- 1. Carl & Emma Clark Estate No. 2; KPB File 2026-056
Johnson Surveying / Wilson
Location: MP 17 Hope Highway
Hope Area / Hope-Sunrise APC**

**ITEM #1 - PRELIMINARY PLAT
CARL & EMMA CLARK ESTATE #2**

KPB File No.	2026-056
Plat Committee Meeting:	June 22, 2026
Applicant / Owner:	Ronald W. Wilson of Hope, Alaska
Surveyor:	Jerry Johnson; Johnson Surveying
General Location:	Hope Highway near milepost 17, Hope Area

Specific Request / Scope of Subdivision: The proposed plat will subdivide an 88.277-acre parcel into two tracts consisting of 77.831 acres and 10.444 acres.

Carl & Emma Clark Estate #2 Preliminary Plat

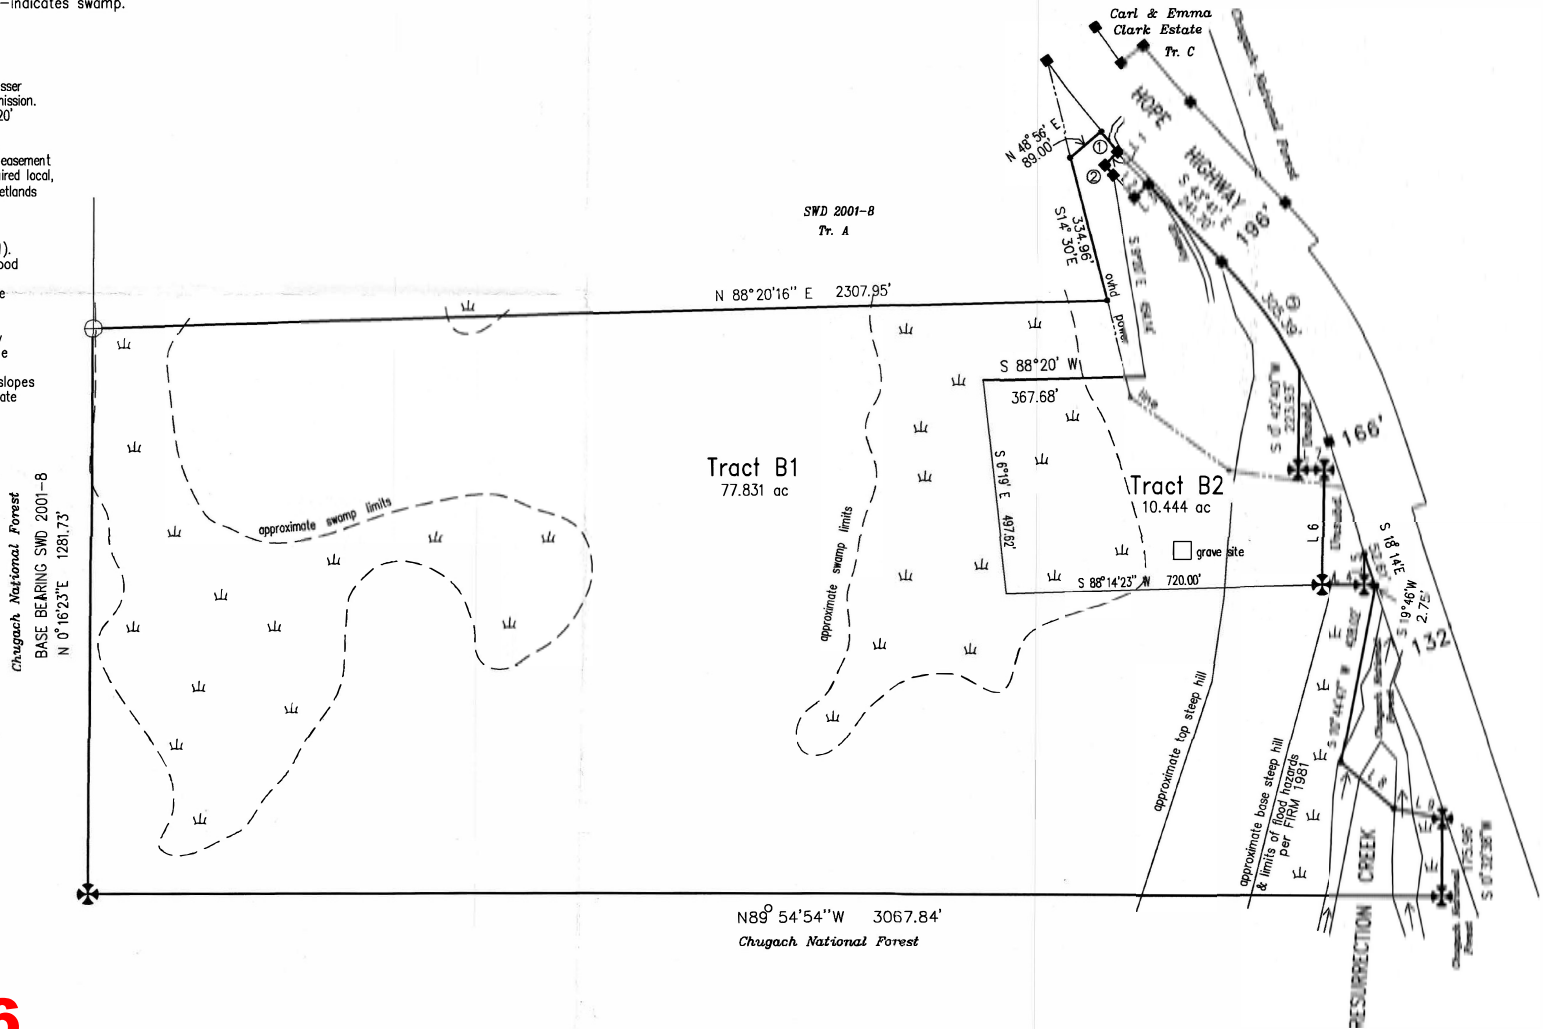
Based on available imagery and USS 1092 (HES 71), a trail extends from the southern boundary of Tract B2 through Tract B1 into the Chugach National Forest. **Staff recommends** the applicant verify whether the trail will be granted as an easement or labeled as a private trail.

Based on available imagery and KPB Assessing records, proposed Tract B2 contains improvements. **Staff recommends** the surveyor verify that no encroachments will be created by the placement of the new lot line.

A private grave site is present within proposed Tract B2 is noted. If this is the site referenced within an easement recorded in deed at Bk 3855 Pg 781, **staff recommends** the depiction remain with a reference to a plat note containing the easement information and reference to the Private Clark Family Cemetery.

Resurrection Creek runs adjacent to and within the southeastern portion of the subdivision and has been identified by the KPB reviewers as located within an Anadromous Waters Habitat Protection District. **Staff recommends** Revising Plat Note 7 to match KPB 20.30.290.

There are a couple of low wet areas within the subdivision. One area to the west is depicted, and another lies along Resurrection Creek. A wetland determination plat note is present. **Staff recommends** modifying the legend to reflect the appropriate source used for the wetland information and updating the label to reflect consistent terminology by the source.

The proposed subdivision is located within flood hazard areas Zone A and C. Zone C is a non-regulatory flood zone of unknown risk; Zone A is a regulatory flood zone. **Staff recommends** Modifying the Flood Hazard Plat note to reference both flood zones. Zone A should be depicted and labeled. Plat Note #6 and the Floodway Notice may

be removed, as there is no floodway present. The River Center Flood Plain Administrator in reference to KPB 20.30.280(A) suggested this site have a base flood elevation established for it. The surveyor has requested an exception to KPB 20.30.280(A).

KPB contour information is not available for this area. Plat Note 8 states that the terrain slopes towards the west, with some areas around 15% grade. The hill depicted near Resurrection Creek contains slopes over 25% grade. This looks to slope to the east towards Resurrection Creek.

Proposed Tract B1 is a flag lot design with the access portion being approximately 62.53 feet wide. **Staff recommends** Adding the standard flag lot note to the final plat: No structures or wastewater disposal permitted within the panhandle portion of Flag Lot B1.

The parent plat (SW 2001-8) granted 10-foot utility easements that increased to 20 feet within 5 feet of the side lot lines along Hope Highway. Plat Note 1 carries forward this easement on the proposed plat. **Staff recommends** the note include the granting source of the easement (SW 2001-8).

There is a recorded easement for the benefit of Chugach Electric Association, Inc. The easement does not have a disclosed location. **Staff recommends** Adding a plat note referencing the easement.

- o Correct the minor typo in the Wastewater Disposal Note by moving the period "...onsite wastewater treatment and disposal."
- o In the Flood Hazard Notice, correct the spelling of area in flood hazard area district.
- o Solid square is not shown in legend, please add.

- o Add SE1/4 Section 29 to legal description
- o Add KPB File No 2026-056
- o Change 'prepared for' to 'Owner'

- Depict and label the section lines and sections on the drawing: S29, S28, S33, and S32
- D. A vicinity map, drawn to scale showing location of proposed subdivision, north arrow if different from plat orientation, township and range, section lines, roads, political boundaries, and prominent natural and manmade features, such as shorelines or streams;
Staff recommendation:

- Depict and label the following: Porcupine Creek, Cripple Creek, Wildhorse Creek, and Bear Creek.
- E. All parcels of land including those intended for private ownership and those to be dedicated for public use or reserved in the deeds for the use of all property owners in the proposed subdivision, together with the purposes, conditions, or limitations of reservations that could affect the subdivision;
Staff recommendation:

- Add CTP items #9, #11 and #12
- F. The location, width and name of existing and platted streets and public ways, railroad rights-of-way, easements, and travel ways existing and proposed, within the subdivision;
Staff recommendation:
There appear to be trails crossing the plat into the Chugach National Forest shown on the Survey No 1092. Identify trails as public or private on the drawing.

- Provide a label to the south “unsubdivided”
 - Modify the labels for the parcels abutting the subdivision to the east for clarity purpose: Hope Ranger Station and Hope Cemetery (USS 1092)

- Kettle shown on preliminary plat as “swamp”. Modify label to “low wet areas” and within the legend, provide source of wetland determination.
- N. Apparent encroachments, with a statement indicating how the encroachments will be resolved prior to final plat approval;
Staff recommendation:

- Trail located from Tract B2 through Tract B1.
